### 3/4.4.6 PRESSURE/TEMPERATURE LIMITS

BRUNSWICK STEAM ELECTRIC PLANT, UNITS 1 AND 2

REQUEST FOR LICENSE AMENDMENT

REMOVAL OF PRESSURE-TEMPERATURE CURVES AND VESSEL SURVEILLANCE

FIGURE 3.4.6.1-1  
PRESSURE-TEMPERATURE LIMITS  
REACTOR VESSEL

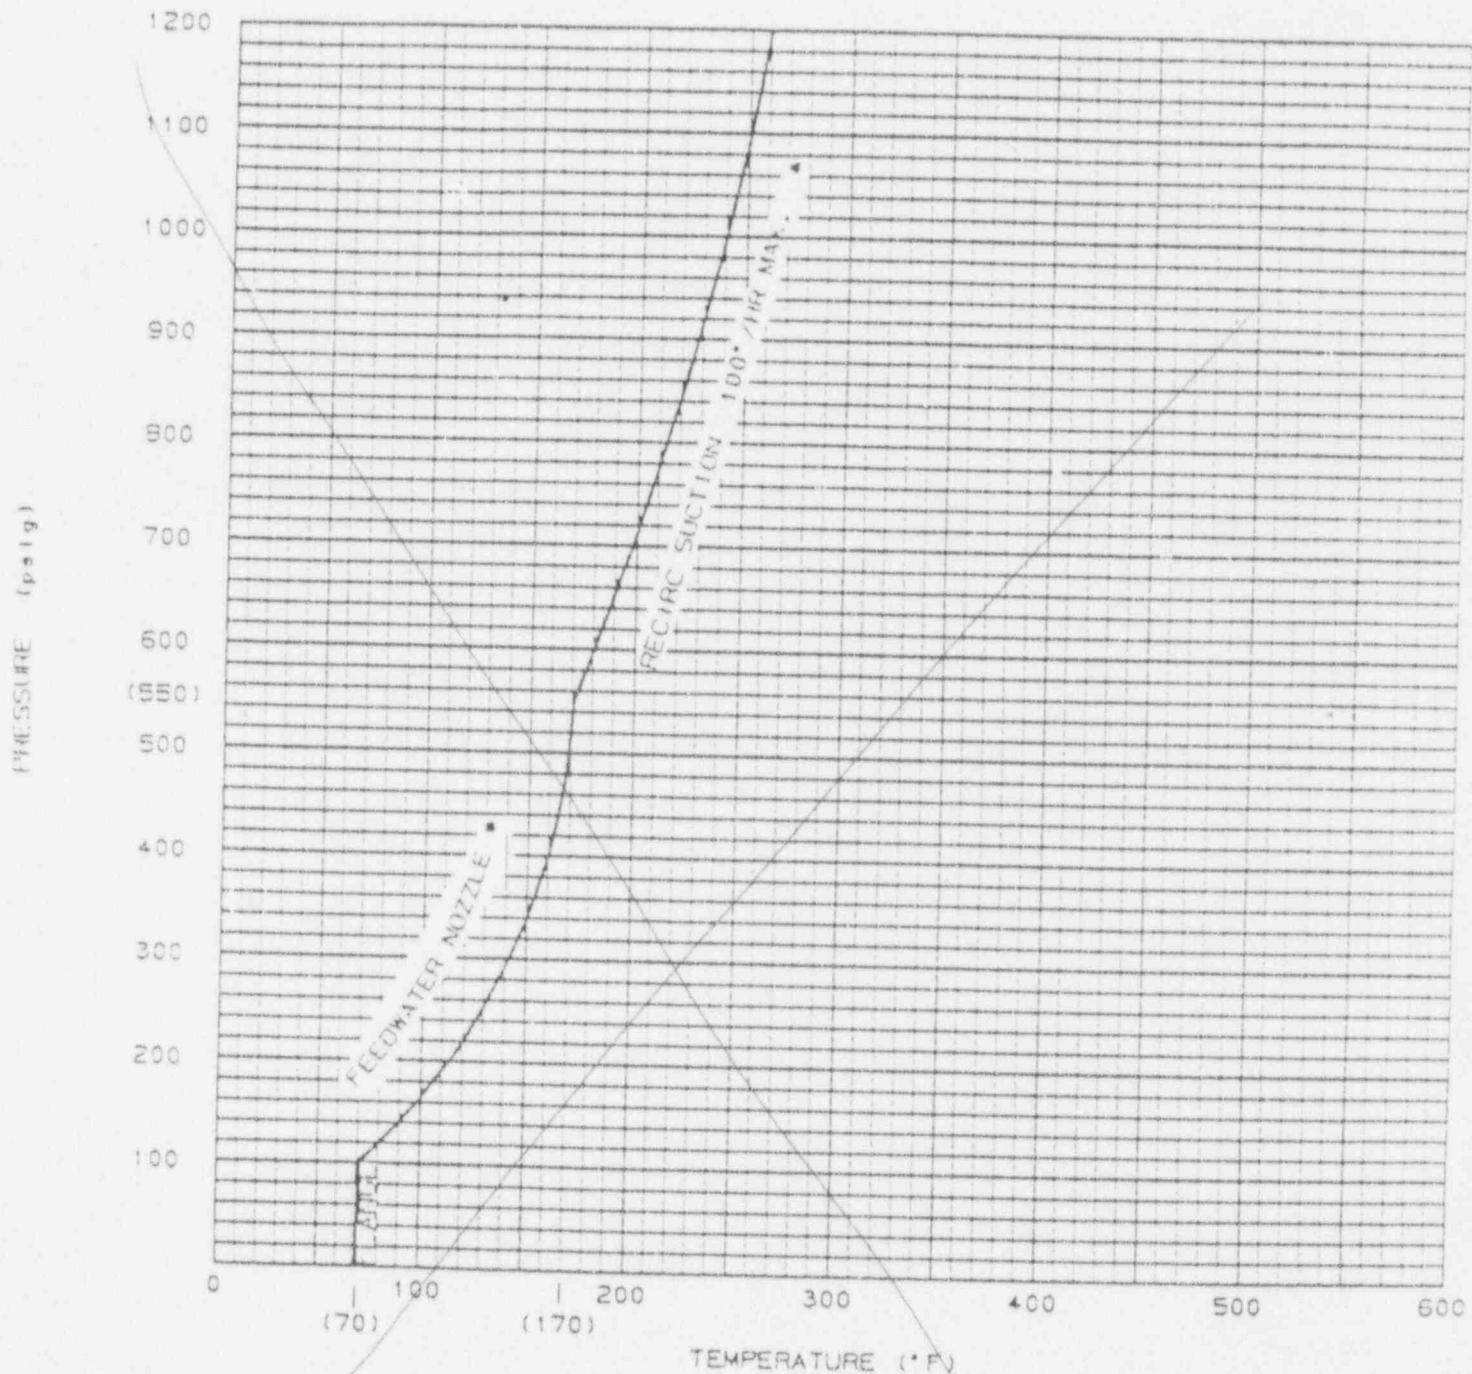
Delete

FIGURE 3.4.6 1-2  
PRESSURE-TEMPERATURE LIMITS  
REACTOR VESSEL

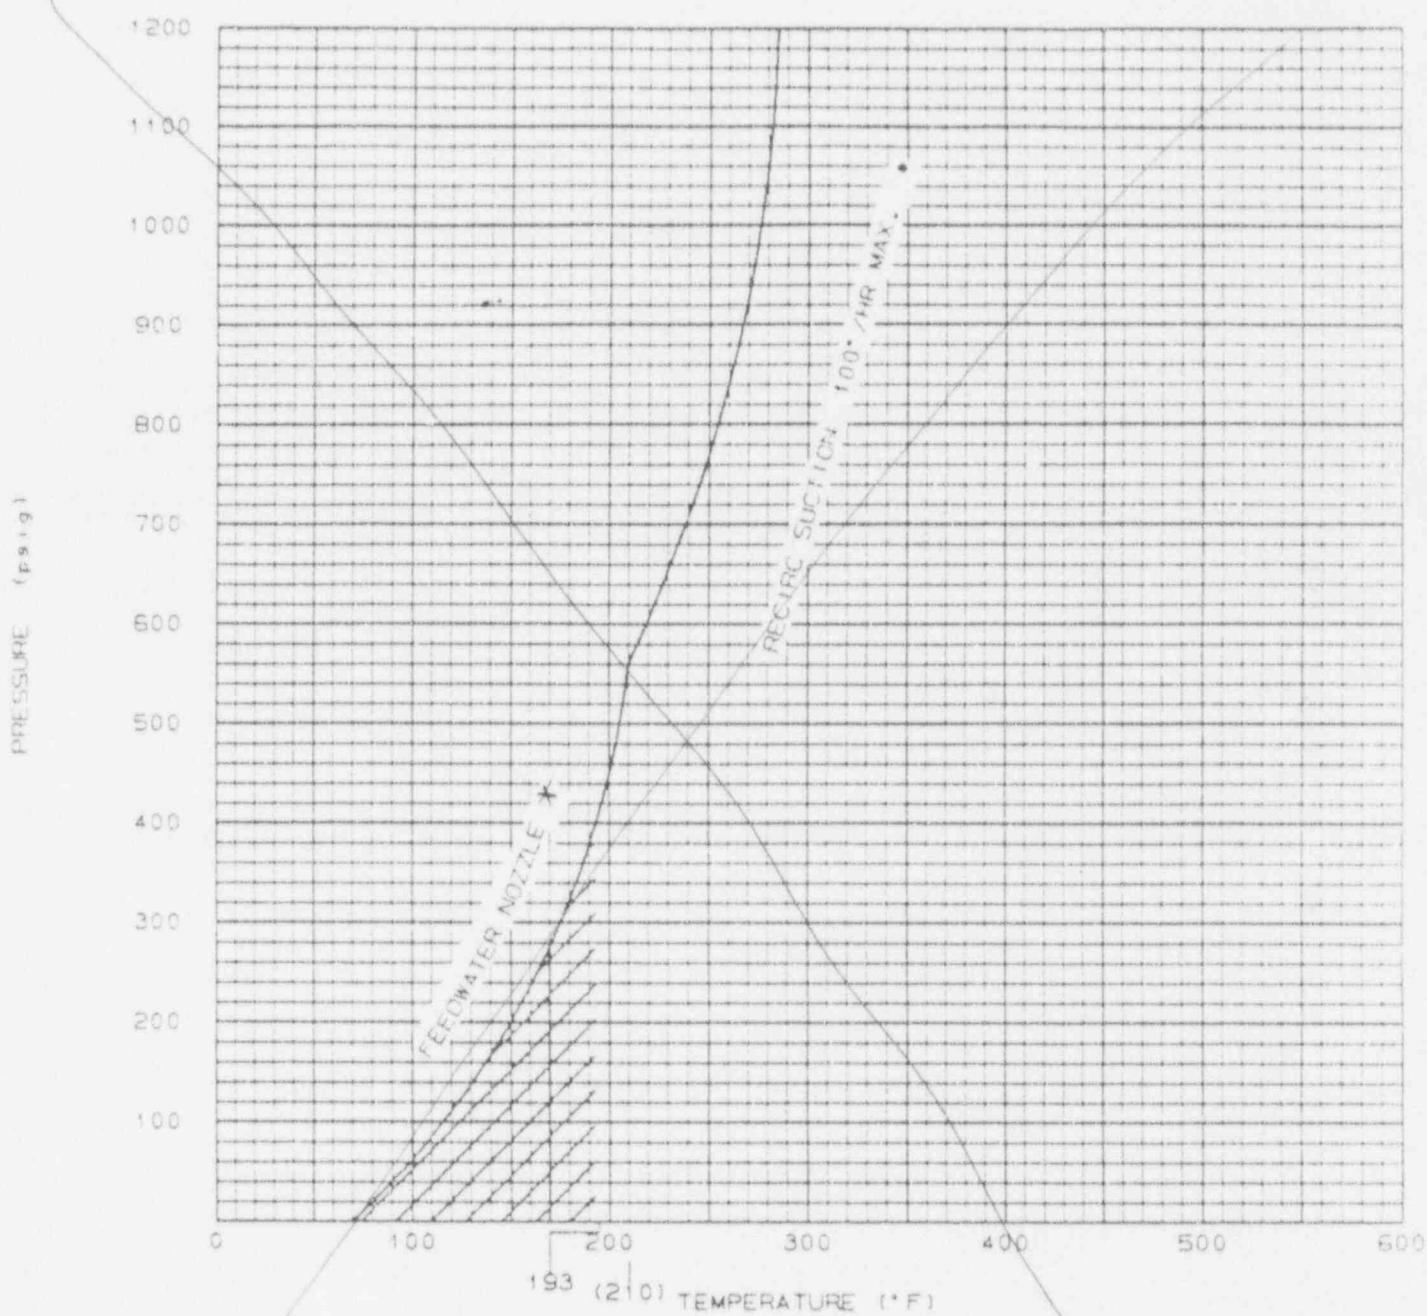
*De be fer*

FIGURE 3 + 6.1-3a  
PRESSURE-TEMPERATURE LIMITS  
REACTOR VESSEL

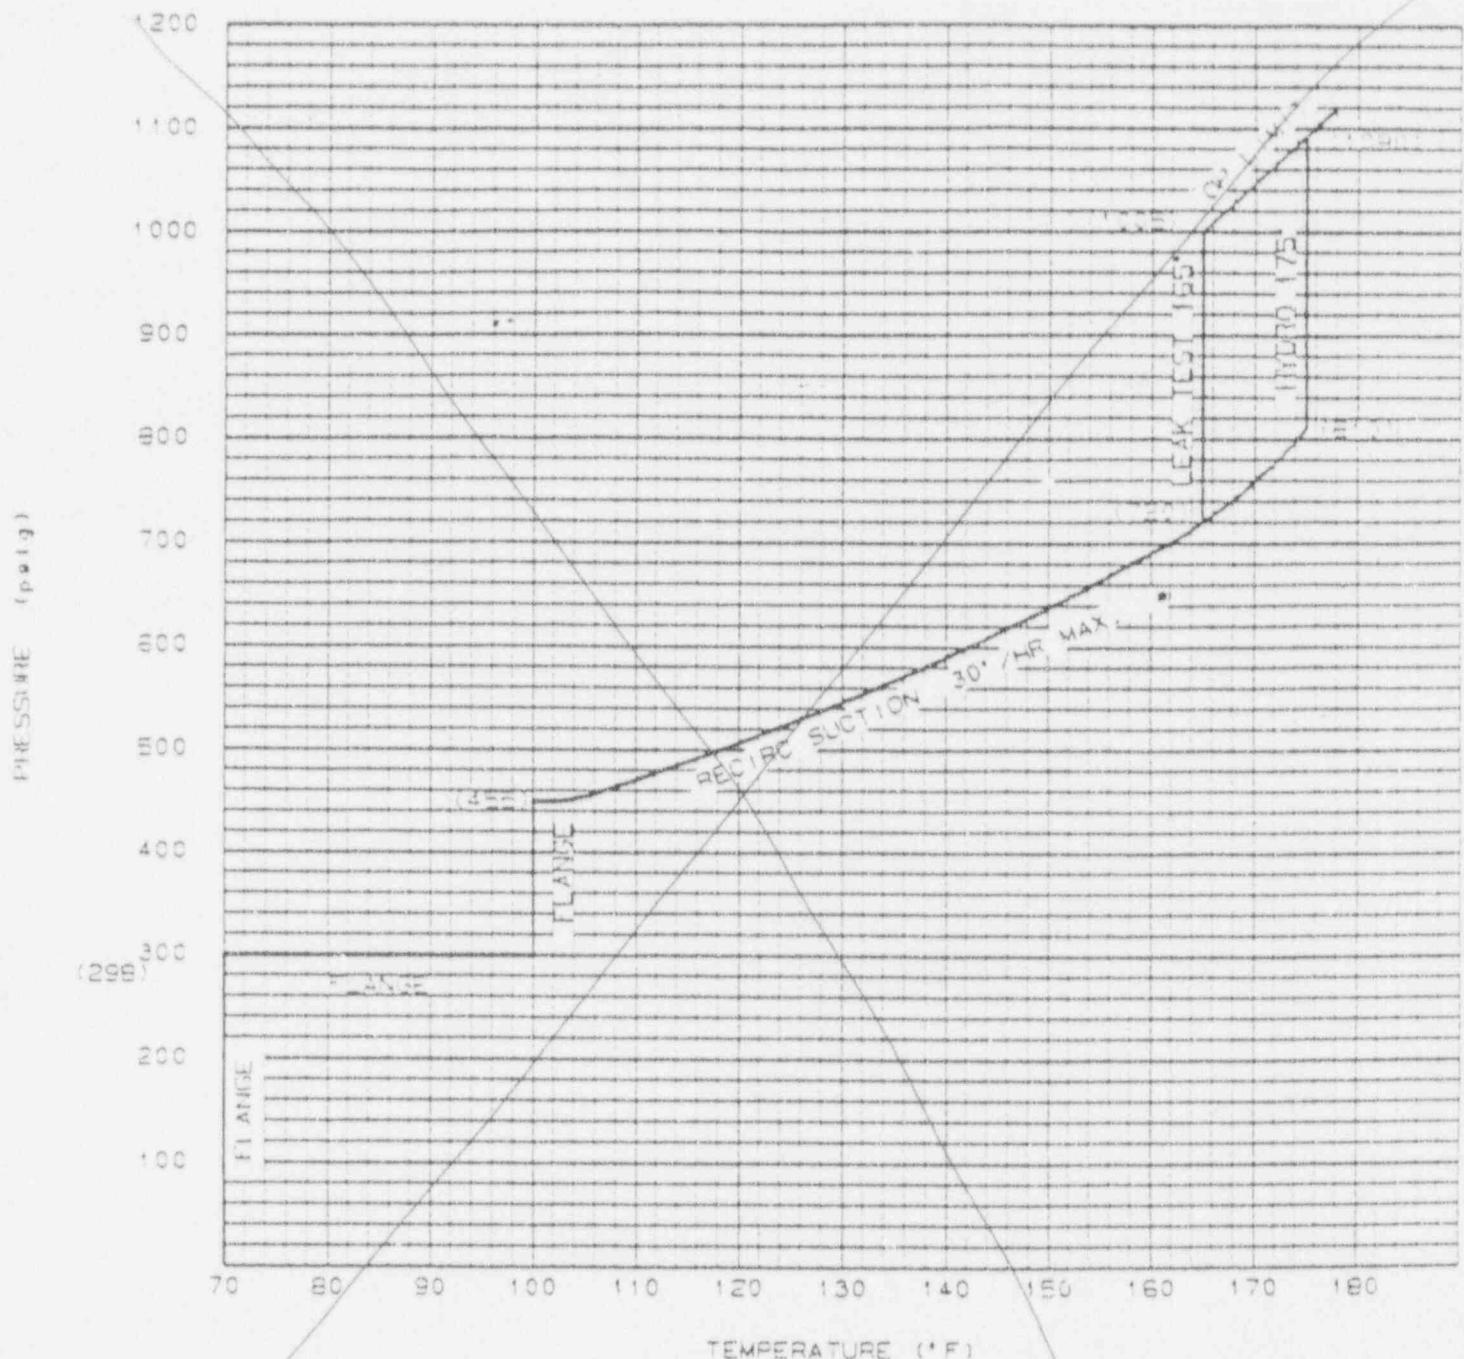
Delete

FIGURE 3.4-6.1-3b  
PRESSURE-TEMPERATURE LIMITS  
REACTOR VESSEL

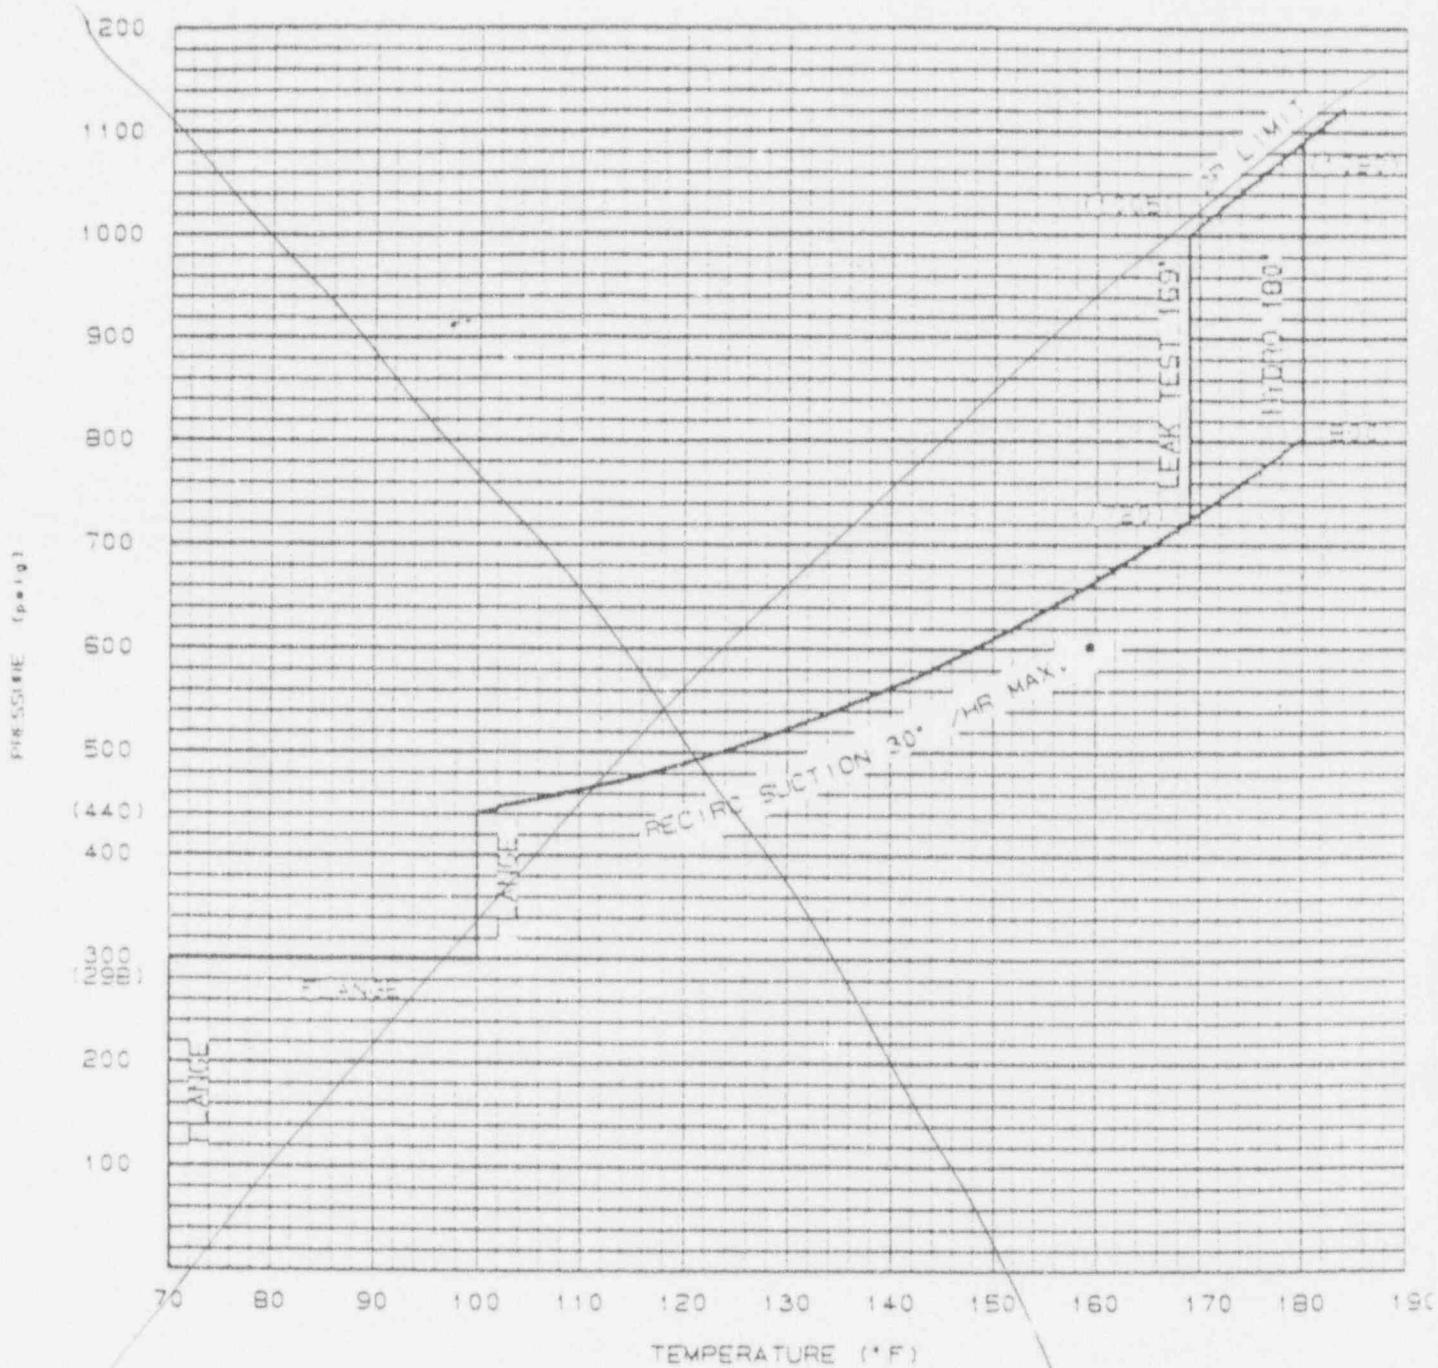
*Delete*

FIGURE 3.4.6.1-3c  
PRESSURE-TEMPERATURE LIMITS  
REACTOR VESSEL

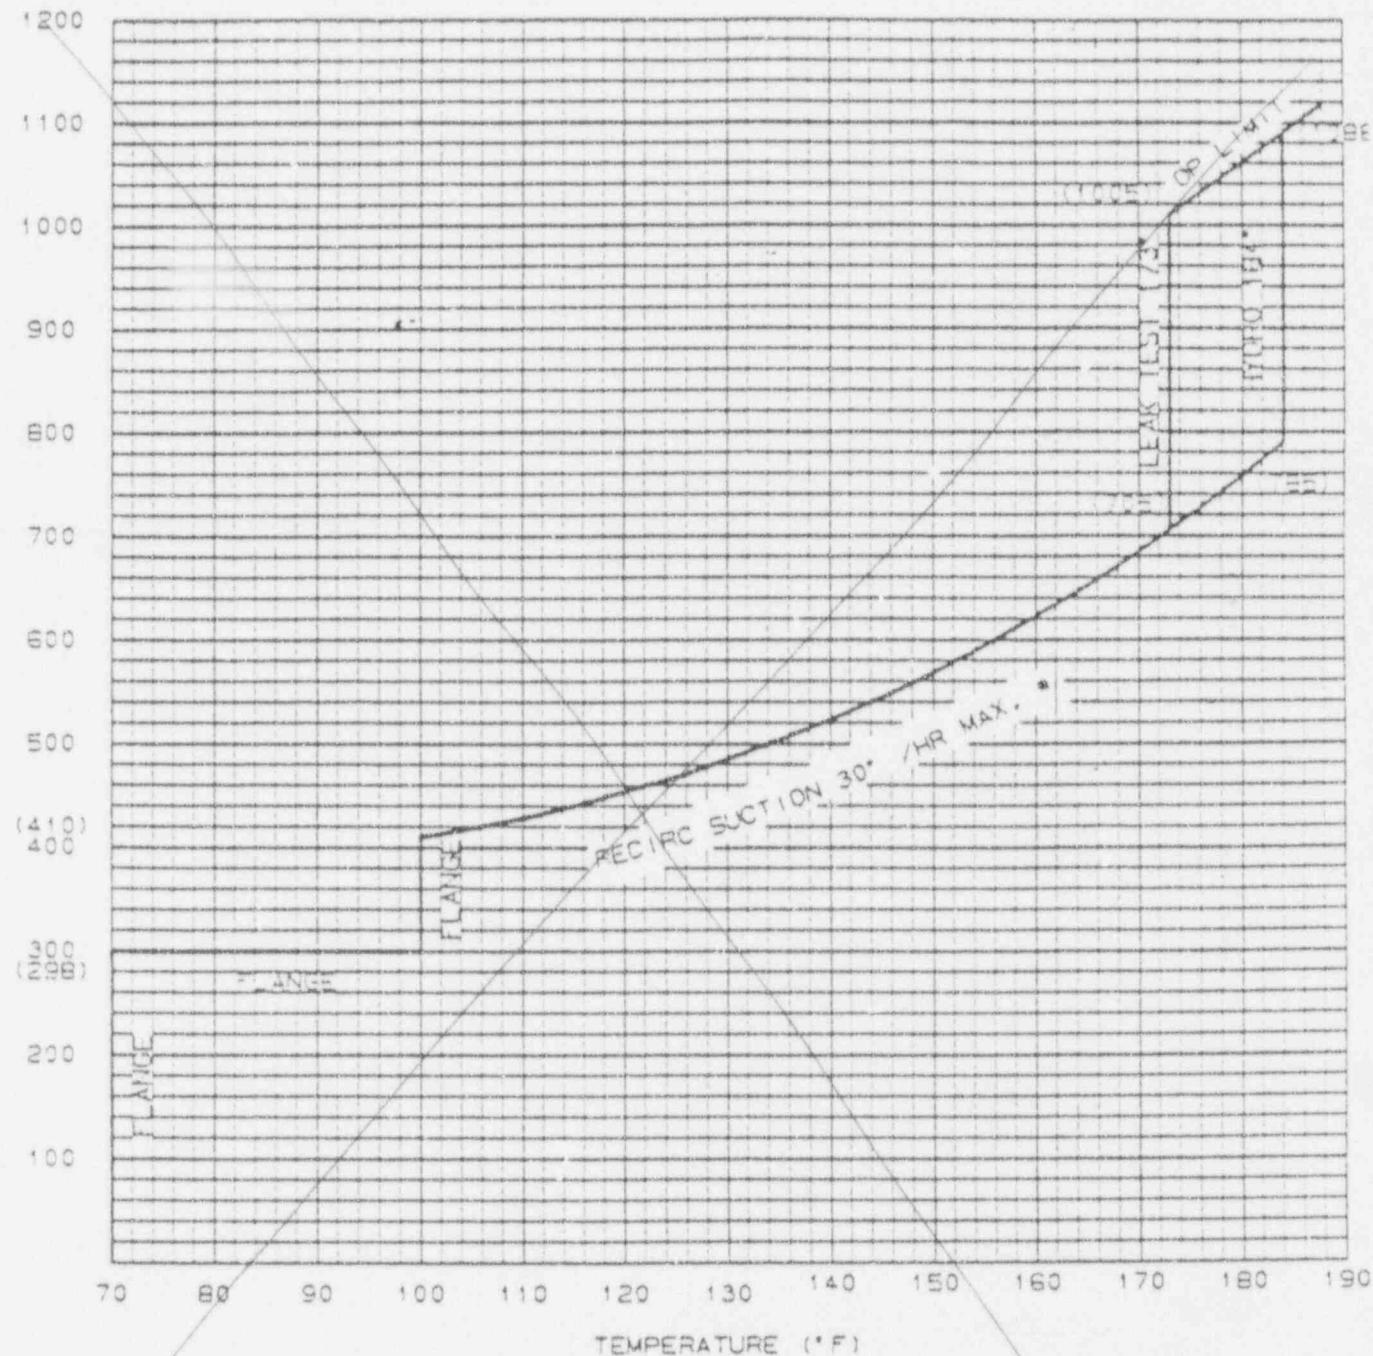
*Delete*
